BLOCKING DIAGRAM ~ LINE 2

REVISIONS			PRINT RECORD		
NO	DATE	DESCRIPTION	DATE	QTY	ISSUED
			6-15	5	Appr
<b>MEGQUIER &amp; JONES INC.</b> STRUCTURAL STEEL SINCE 1895 1156 BROADWAY SOUTH PORTLAND, MAINE 04106					
PAINT		HOLES U N	WELD U N	Q C REVIEW	
PROJECT TH NO.1 OVER THE GIHON RIVER PROJECT NO. BHO 1448 (29) BRIDGE NO. 5 TOWN OF JOHNSON, VERMONT			DATE 6-8-09		
DESCRIPTION BLOCKING DIAGRAMS ~ LINE 2			DRAWN BY 5-22-09		
ARCH N/A		ENGR VERMONT AGENCY OF TRANSPORTATION		JOB NO J-81	
CUSTOMER S.D. IRELAND CONCRETE CONSTRUCTION CORP.			CHK'D BY CJC		
			JOB NO J-81		
			SHT NO BD2

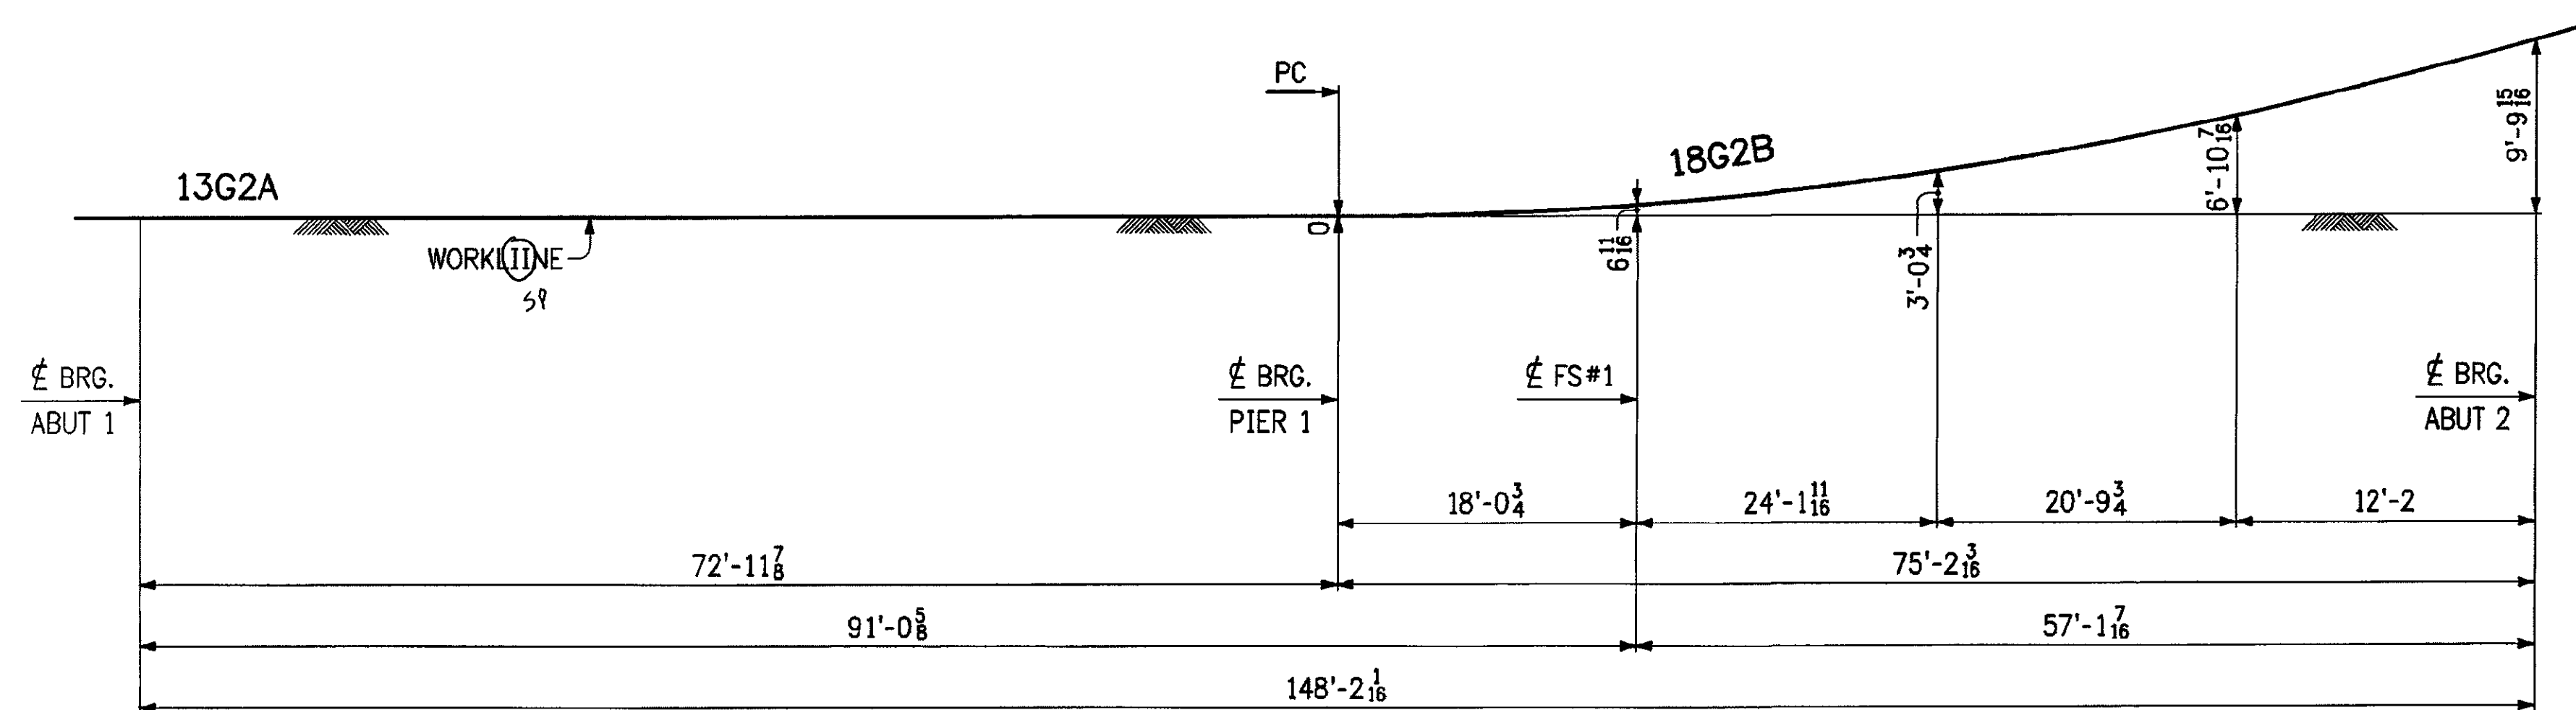
Accepted	
Accepted as Noted	✓
Accepted Noted Resubmit	
Rejected, Revise Resubmit	
Rejected - Unacceptable	
Checking is only for conformance with the design concept of the Project and compliance with the information given in the Contract Documents. The Engineer assumes no liability for errors or omissions that may be contained herein. The Contractor, by approving and submitting these documents, verifies their accuracy as stipulated on the Contractor's Shop Drawing Stamp.	
Date: 7/7/09	DuBOIS AND KING Rv. <i>[Signature]</i>
